# Directive

**Directive No.:** 7

**Project Name:** GST AP Apron, Runway, and Taxiway Pvmnt Rehab

This Directive summarizes verbal direction given to the Contractor on 4/26/21. This Directive amends some of the containment cell and stockpile details that were provided in IWA 11.

# Asphalt Material Handling Map

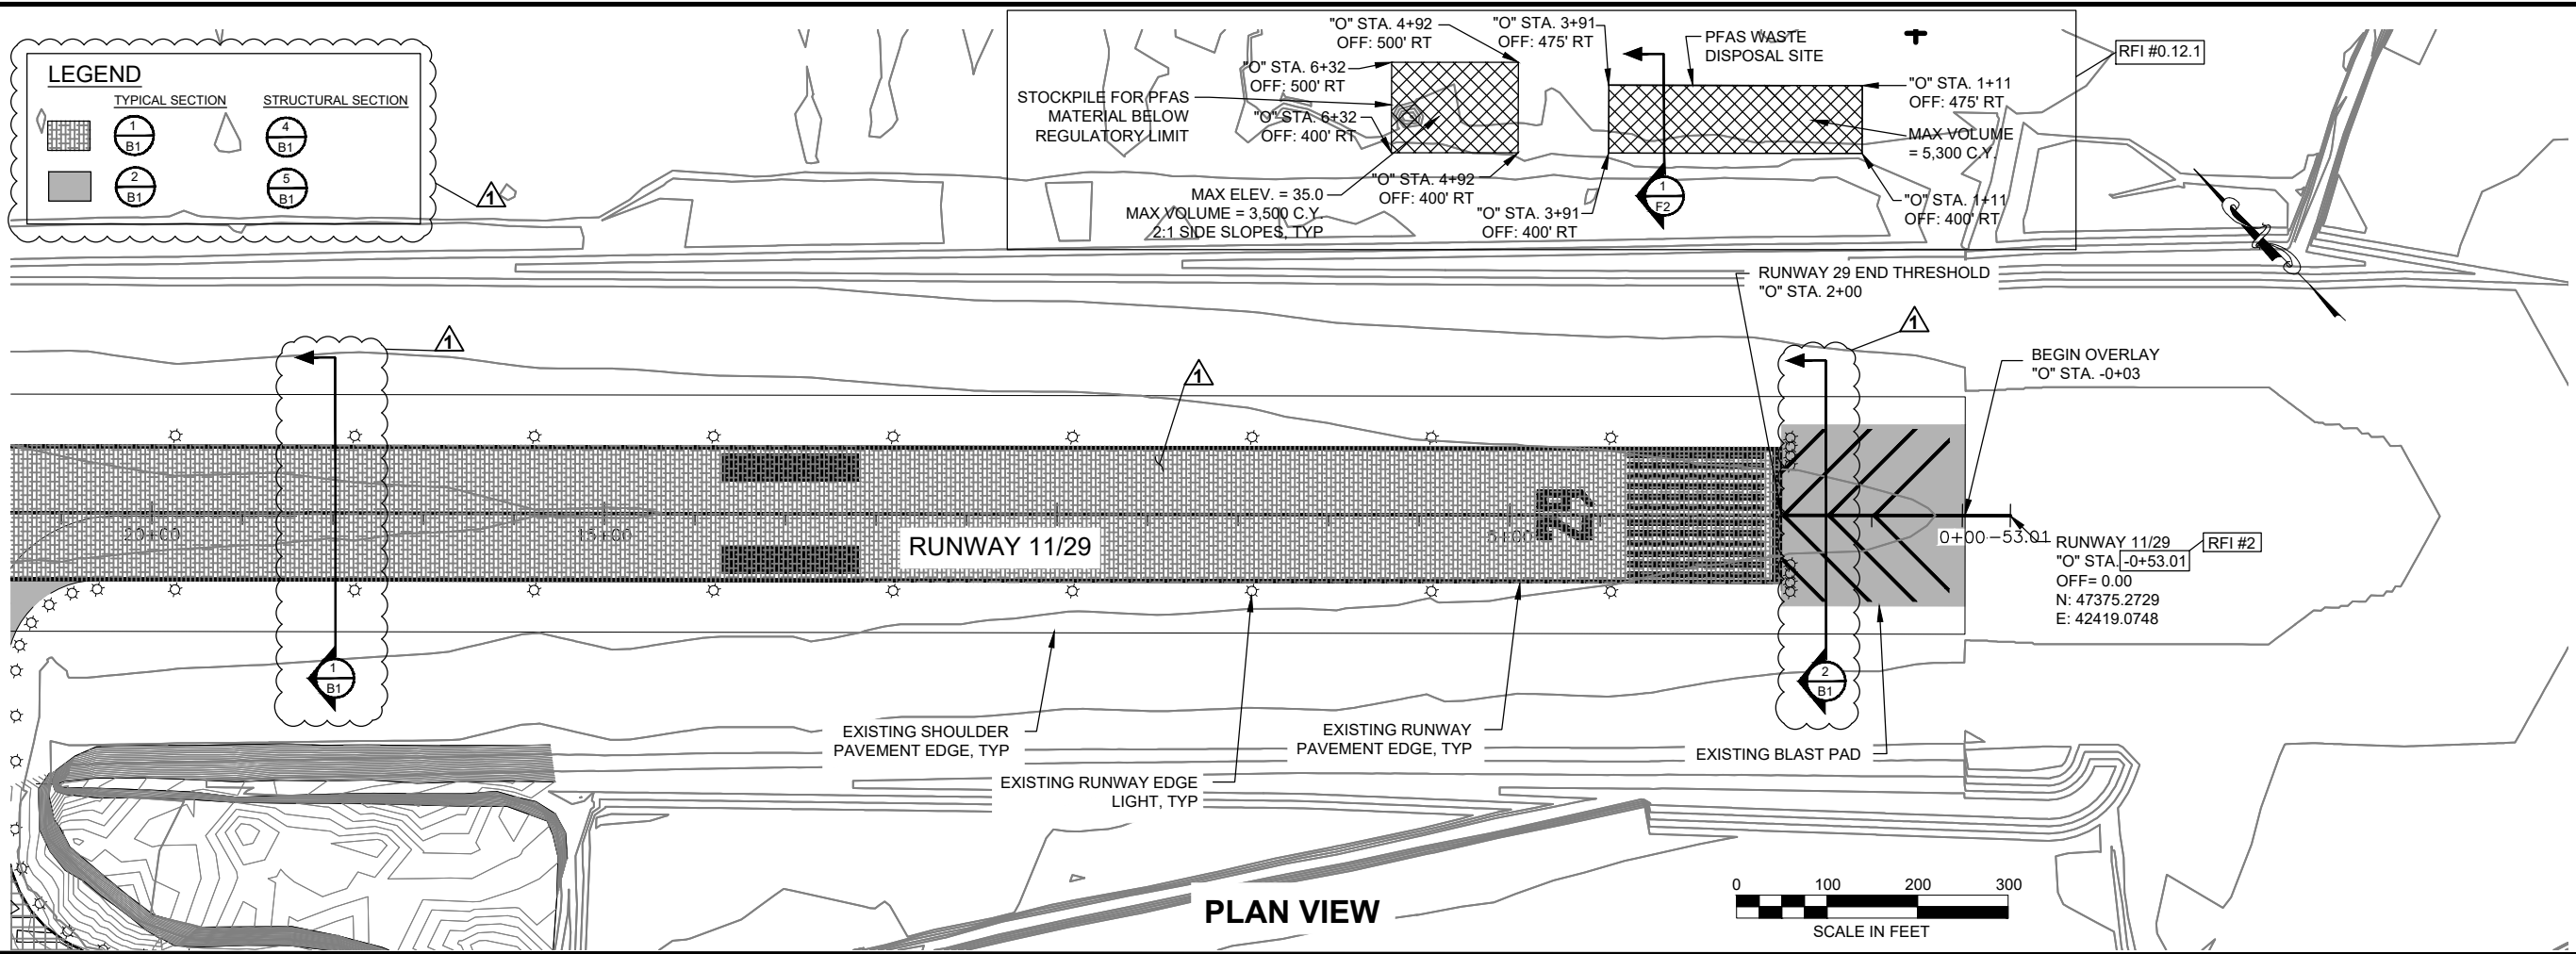
- 3.) The haul route shown in blue in "Attachment 1" is acceptable if hauling operations are coordinated with the CVO and Airport Manager. A NOTAM shall be issued to advise pilots of potential vehicles on the runway. The CVO must actively monitor for aircrafts on the radio and visually. This amends the CSPP subsection 2.05(a).

Old concrete hardstands from GAA temporarily stockpiled at "Location #2". Shall be separated from other RAP so that it can be tested and possibly removed at a later date. Stockpile shall be covered with plastic sheeting. Compensation under IWA 05.

Acceptable Haul Route coordinated with CVO and Airport Manager

SHEET NO.	TOTAL SHEETS	
F2	13	
STATE	YEAR	
ALASKA	2020	
PROJECT DESIGNATION		
Z675170000/ 3-02-0111-007-2020		
ADDENDUM NO.		
ATTACHMENT NO.		
REVISIONS		
NO.	DATE	DESCRIPTION
1	6/4/20	ADDENDUM 1
	10/6/20	RFI #2
	3/15/21	RFI #0.12
	4/21/21	RFI #0.12.1

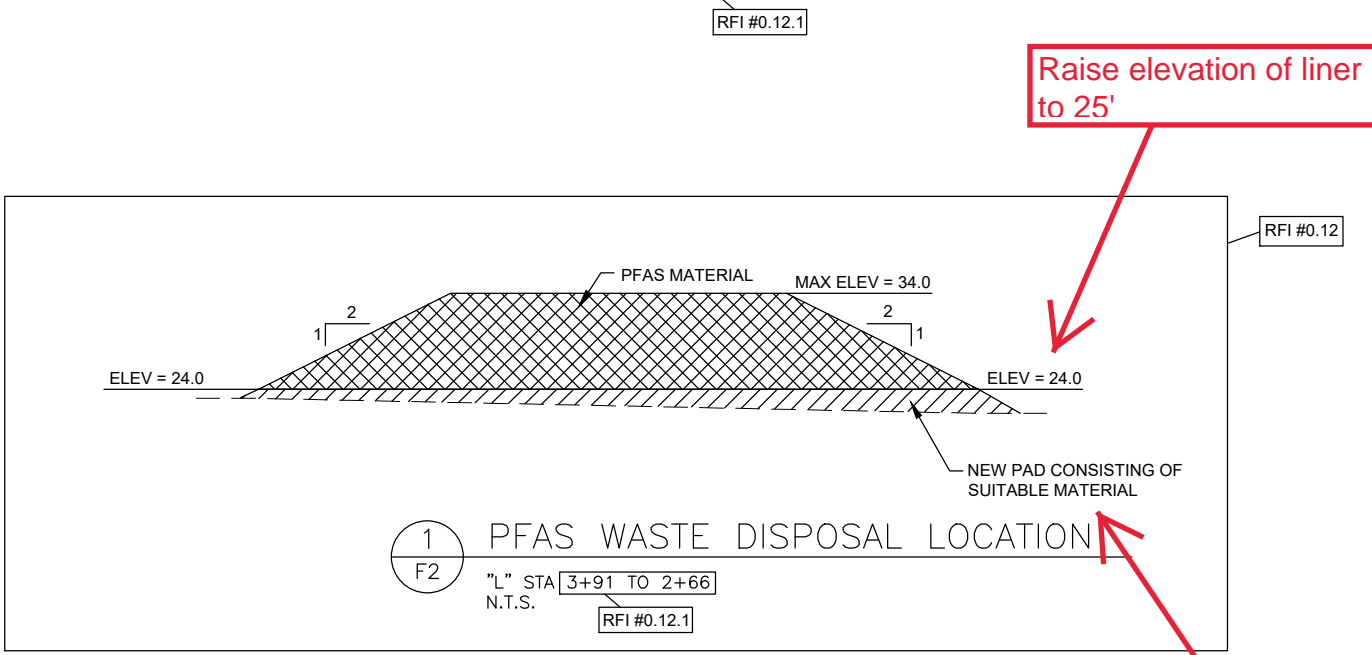
- 1.) The liner elevation on sheet F2 shall be raised from elevation 24.0' to elevation 25.0'. Hauling and filling underneath the liner and PFAS cell construction will be compensated under IWA 05.

- 2.) Excavated sand near PFAS cell that is free of organics may be used as "suitable fill" underneath the liner. Non-contaminated RAP is also acceptable underneath the liner. Organics from nearby berm may be placed as "suitable fill" up to elevation 24.0'.

Organics that are excavated from nearby berm is considered "suitable" up to elevation 24'. Excavated sand from nearby areas that is free of organics is considered "suitable" up to elevation 25'. Non-contaminated RAP is considered "suitable".
